Product Change Notification: E-21-003453

DEUTSCH DT 4,6,8,12-Way Plug and Receptacle Housing Change and Add Second Manufacturing Location

Logo and Text

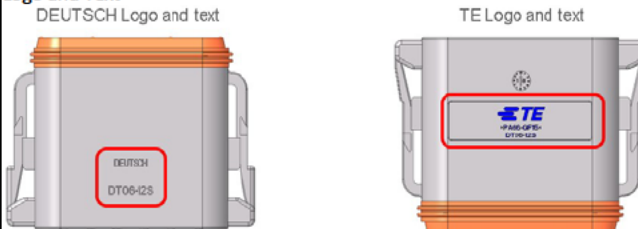
TE-ICT is releasing new capacity tools and making slight form changes to DT 4,6,8,12-Way plug and receptacle housing part numbers, listed below. Changes include: Plug front seals will use seal retention version, logo and part number text, latch ends, and rounded edges. See pictures below and attached presentation for details, 4 and 12-way shown as an example. Also, as part of this initiative, TE-ICT is adding a second manufacturing location in China. CN will be added for those PNs manufactured in China to indicate the country of origin. These PNs are TE proprietary designs, therefore considered catalog/general market product. PPAP and/or sample requests must be submitted via ict-ppap-request@te.com or ePPAP system. PPAPs will be completed by part family and will be available upon request only. All PPAP requests must be received within 14 days of receipt of this notification. Product drawings are affected and will be updated as the changes are phased in.
